**BEFORE THE PUBLIC UTILITIES COMMISSION OF
THE STATE OF CALIFORNIA**

Rulemaking 14-07-002
(Filed July 10, 2014)

**COMMENTS OF THE ALLIANCE FOR SOLAR CHOICE, THE SOLAR ENERGY
INDUSTRIES ASSOCIATION, AND THE CALIFORNIA SOLAR ENERGY INDUSTRIES
ASSOCIATION ON THE DRAFT VERSION OF THE PUBLIC TOOL**

Figure 1. Drop-off in Adoption Despite Continued Policy Support

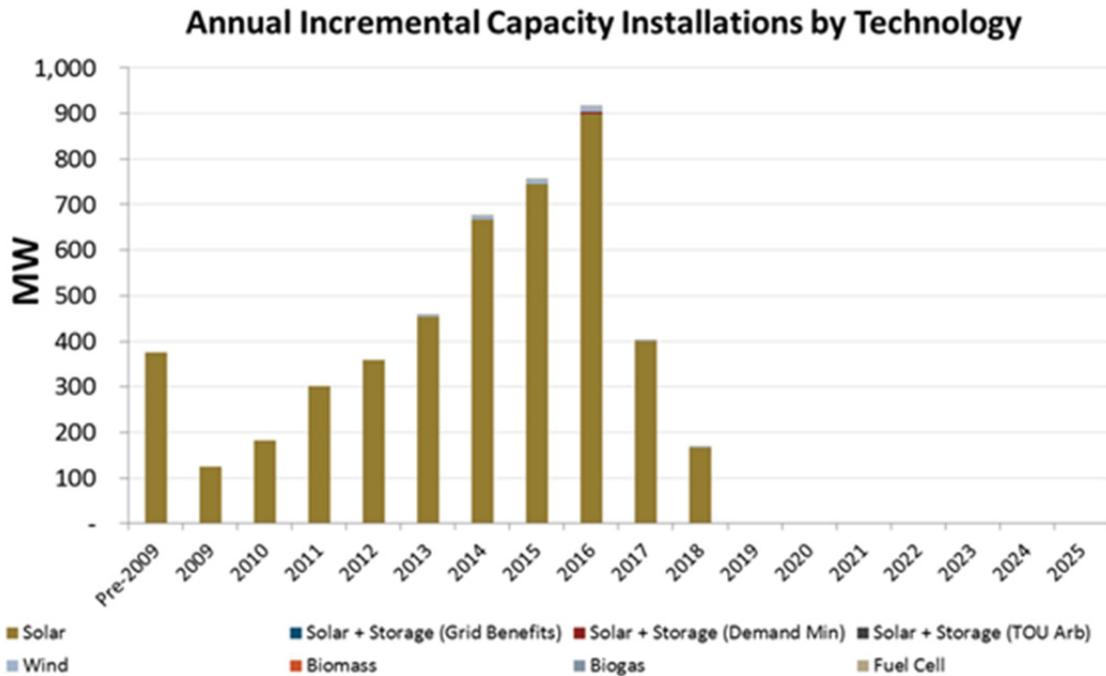
A “business-as-usual” case for 2017 demonstrates that the adoption model is faulty. Such a case includes: (1) the federal Investment Tax Credit (ITC) stays at 30% in 2017 then drops to 10% in 2018; (2) NEM remains at the full retail rate credit; (3) the existing four-tier rate design is preserved; and (4) consumers expect future retail rates to rise at 3% per year, consistent with recent trends and forecasts. In this case, installations in the adoption model fell by 56% from 2016 to 2017, as shown in Figure 1.

In response to a question about this scenario, E3 stated (#1-16) that the problem is not in the adoption model, but in the trajectory of installations shown for 2015 and 2016. This explanation does not make sense because the business as usual installations in 2017 are well below the actual, historical level of adoptions in 2014. Installations should not drop significantly in 2017 compared to actual experience in 2014 if none of the key drivers of solar adoption has changed from 2014.

E3 also suggests, in response to a similar question (#1-17), that the drop in adoptions could be due to the most favorable customer “bins” reaching saturation, such that the rate of adoption would slow. This seems unlikely given that the number of solar customers in the state (250,000 based on the *California Solar Statistics* tally) is less than 3% of the more than 10 million investor-owned utility (IOU) customers, and the addressable market is 35% to 60% of the IOU customer base.

Figure 2. Magnitude of Utility Avoided Costs from Solar⁵

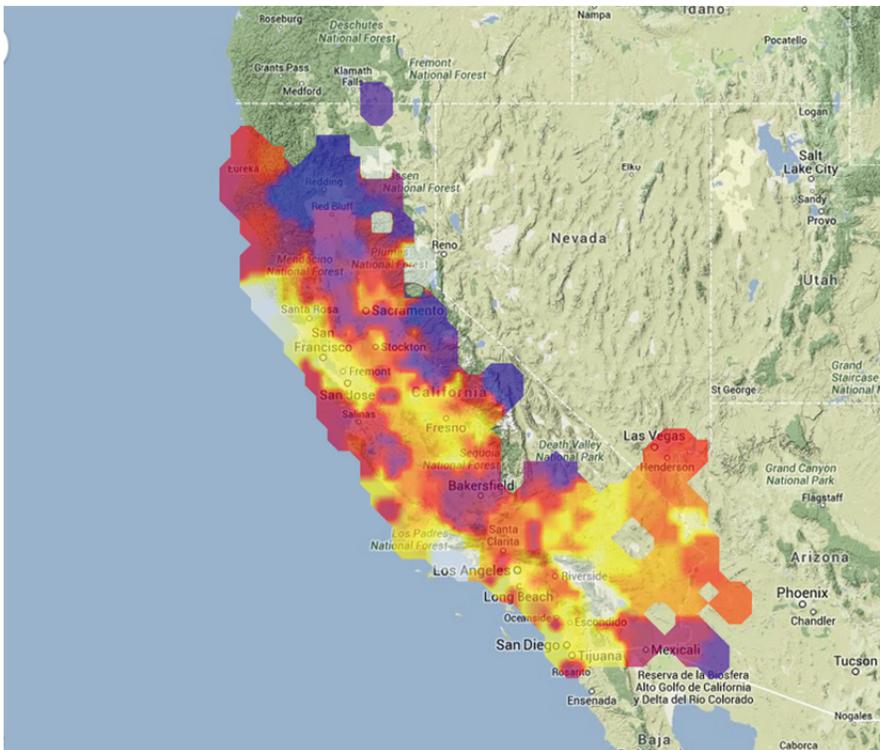
in places where solar installation rates are higher. The Public Tool uses a statewide average energy cost that is not weighted based on the geographic concentration of DER. The Tool therefore undervalues solar because solar historically has offset utility costs in places where costs are high, and this trend should be expected to continue. Locations where the grid is congested are places with a high density of utility customers and therefore a high concentration of DER. Figure 2 is a “heat map” that shows where utility avoided costs from local solar generation are higher. Using 2011 Locational Marginal Prices from CAISO and capacity prices reported by the Commission, the map quantifies the value of energy and capacity associated with latitude-adjusted hourly photovoltaic production estimates that include insolation and cloud cover. White is highest and blue is lowest. Based on the CSI database, the 50 highest value Locational Marginal Price nodes have more than 10 times the capacity of installed solar as the 50 lowest value Locational Marginal Price nodes.

generation and capacity costs. The final Public Tool should allow avoided energy and capacity costs to be adjusted upward to recognize such locational benefits.
